1973 F7-B

PARTS DIAGRAM

SWING ARM/SHOCK ABSORBERS ('71-'73 F7/F7

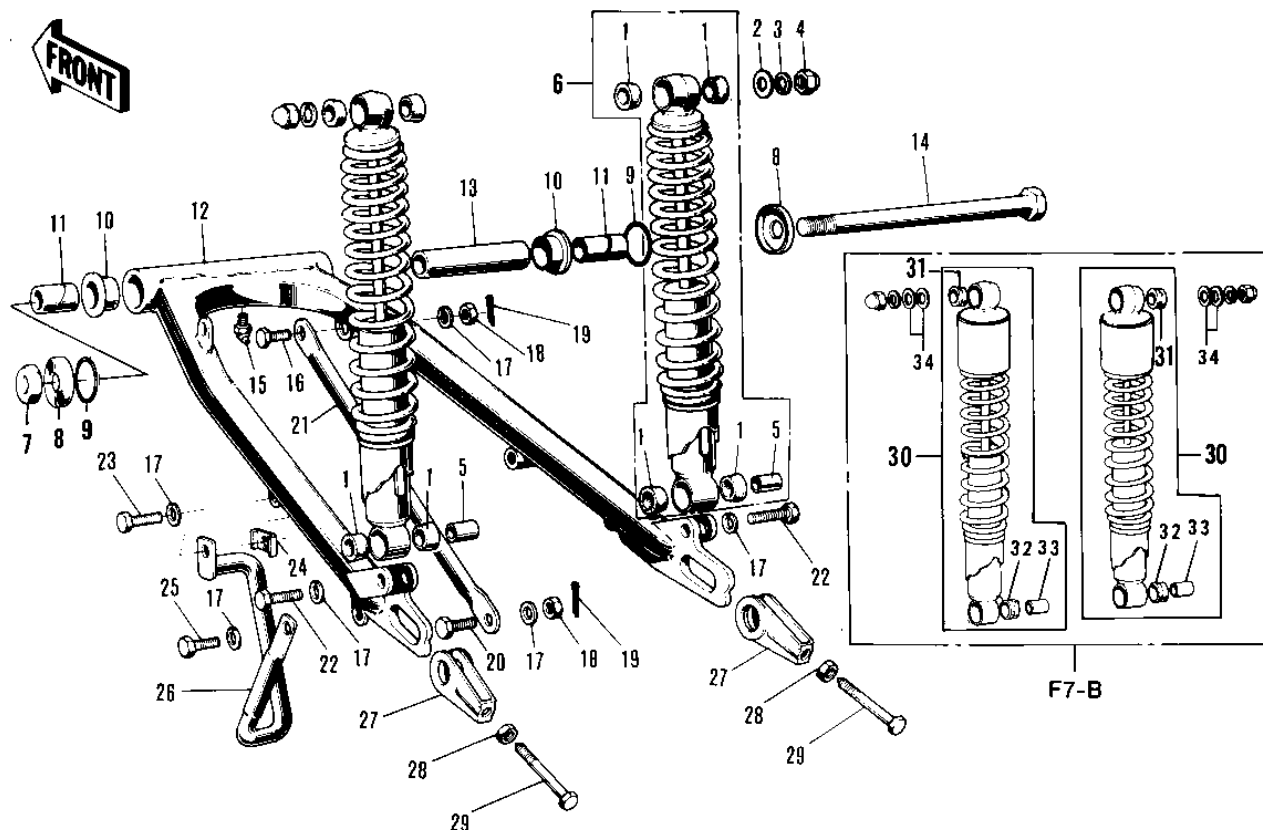
Ref. No. 27, Chain Adjuster		
	OLD	NEW
	1.6 mm 15.2 mm 	3.2 mm 13.7 mm 
Chain Adjuster	33041-041	33041-048
Collar	42032-027	42032-036
Frame No.	~20779	20780~
Interchange?	Use new parts as a set in place of old parts.
